Work Order ID 91973

Item Name: Crosstube Aft

DRAWING NO. D412-664-243	TITLE CROSSTUBE ASSEMBLY (412 HI AFT)	REV. E	DART AEROSPACE LTD ENGINEERING ORDER		D.E.O. NO. D412-664-243-E-1	SHEET NO. SHEET 1 OF 2	SCALE NTS
DRAWN	CHECKED	MFG. APPR.	APPROVED		DE APPR.		
DATE 11.03.31	DATE 11/03/31	DATE 11.03.31	DATE 11/03/31		DATE 11.03.31

D3189-1 CHAFING SHIELD (1, INSTALLED OVER PROSEAL 890)
MS21920-28 CLAMP, 2X
2 PL

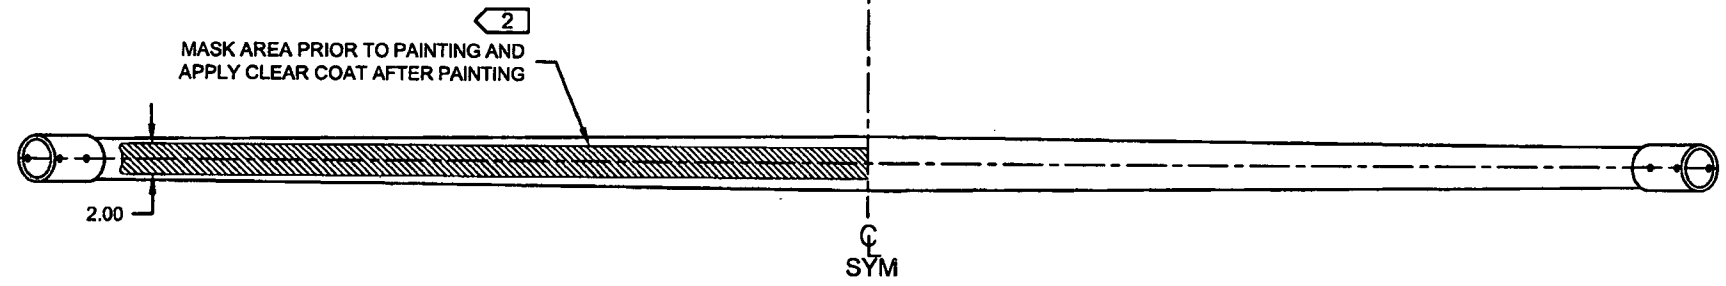
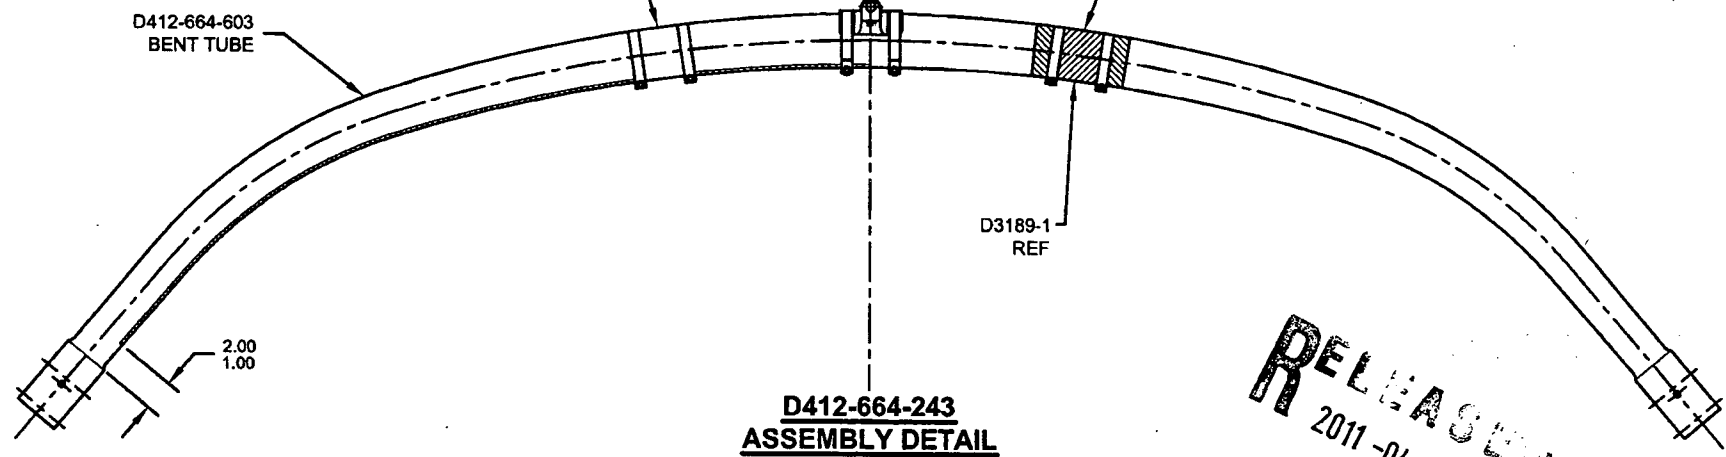
NOTES 2 AND 14, SHEET 1 ARE AMENDED AS FOLLOWS:

WAS:

D2856-600-1009 ABRASION STRIP
D3189-1 CHAFING SHIELD (1, INSTALLED OVER ABRASION STRIP)
MS21920-28 CLAMP, 2X
2 PL

**D412-664-243
ASSEMBLY DETAIL**

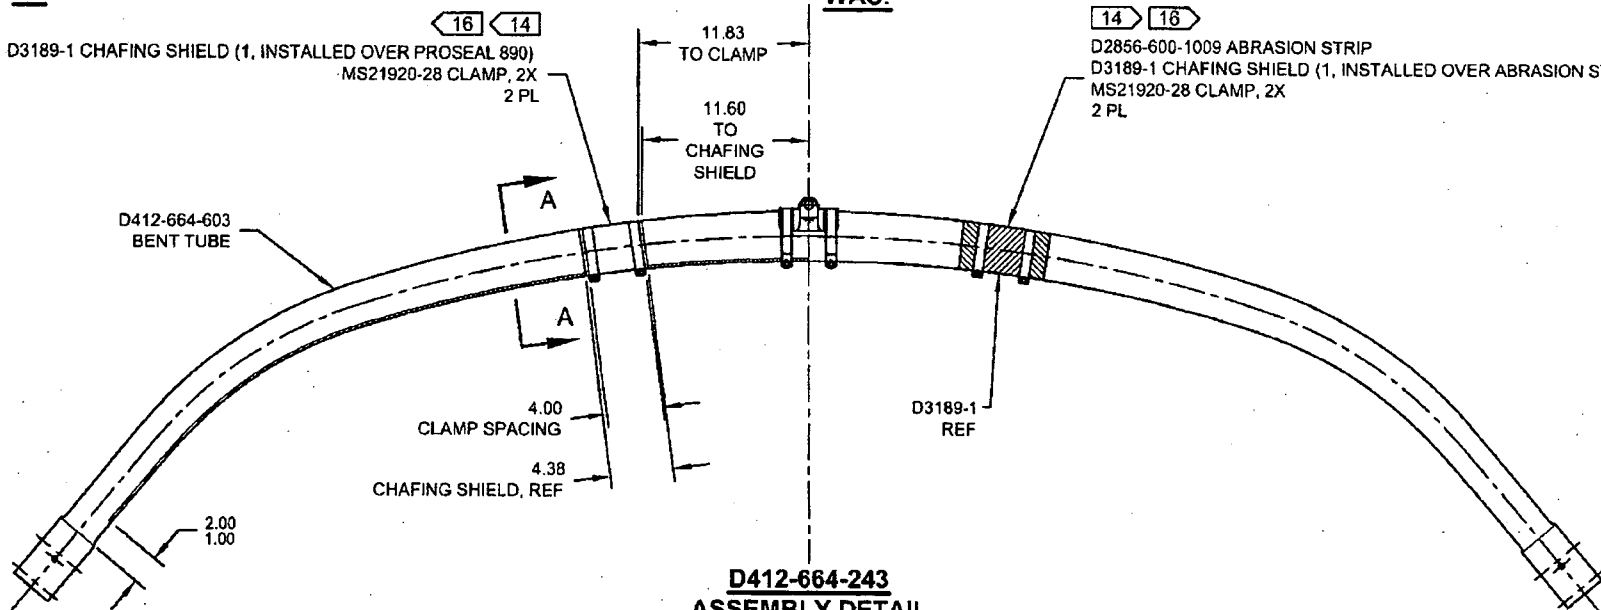
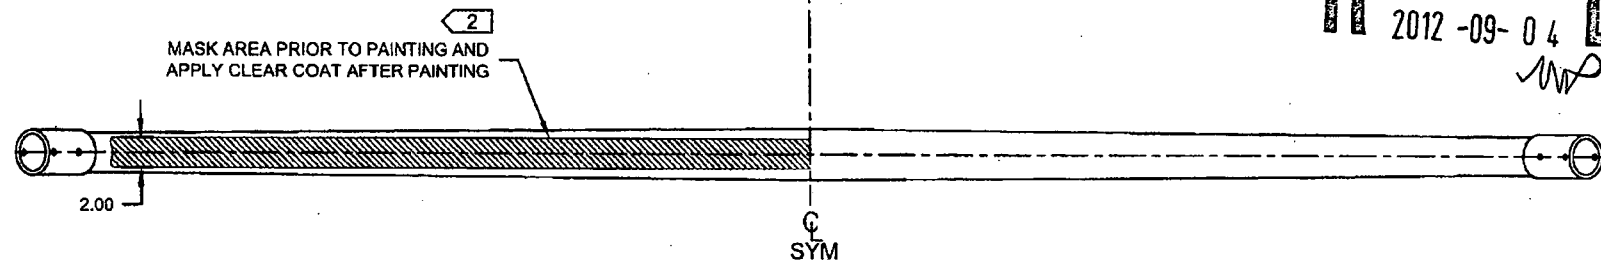
NOTES 2, 14, AND 16 ON SHEET 1 ARE AMENDED AS FOLLOWS:

WAS:

IS:

D3189-1 CHAFING SHIELD (1, INSTALLED OVER PROSEAL 890)
MS21920-28 CLAMP, 2X
2 PL

CRUSHING OF D412-664-243

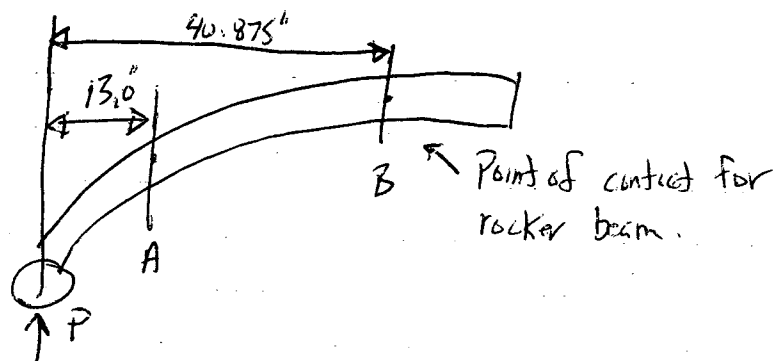
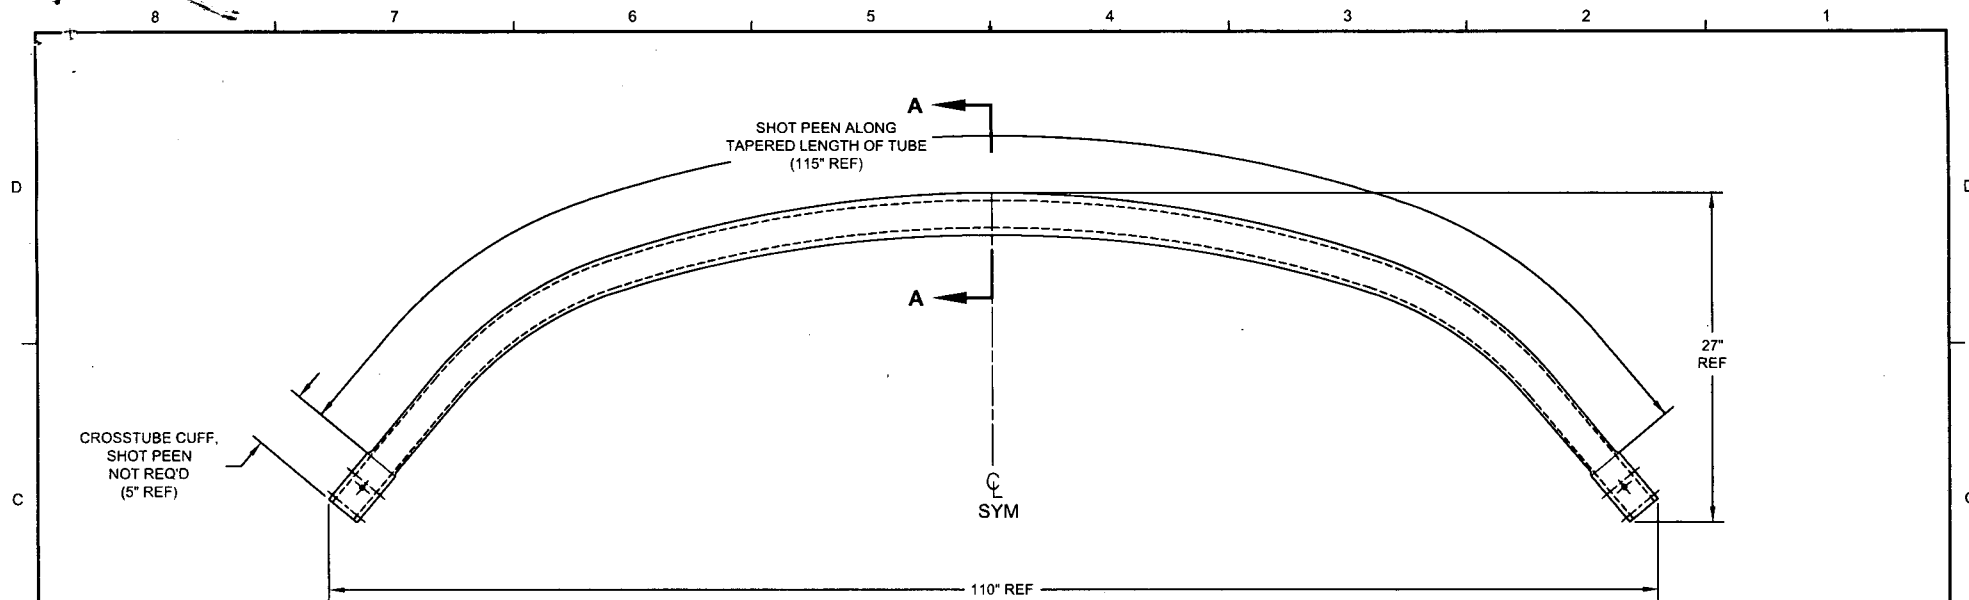
Acceptability of 8% CRUSHING AT END OF BEND

Point A: $OD_1 = 2.961"$, $OD_2 = 2.522"$

Point B: $OD_1 = 3.307"$, $I = 4.613 \text{ in}^4$

A: $F = M_c / I = P \times 13 \times 2.961 / 2 \times 1.676 = 11.484 \cdot P$

B: $" = P \times 40.875 \times 3.307 / 2 \times 4.613 = 14.651 \cdot P$
